INA Service Info

Deflection pulley 532 0662 10

Use with multiple vehicle manufacturer

Fig. 1: Renault and Volvo deflection pulley

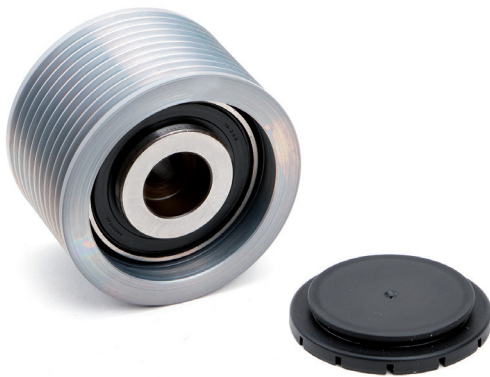
For the accessory unit drive in the engines listed, vehicle manufacturer Renault and Volvo use a deflection pulley with a plastic seal (Fig. 1). In its installed condition, it is equipped with a plastic cap, in order to keep out dirt and water.

Deflection pulley 532 0662 10 is already in use on Mercedes engines and can be used without restriction to replace the deflection pulley shown here (Fig. 1) in Renault and Volvo engines.

Deflection pulley 532 0662 10 (Fig. 2) has the same technical specifications. A steel shield (Fig. 2) seals against penetration by dirt and water, thereby eliminating the need for the additional plastic cap.
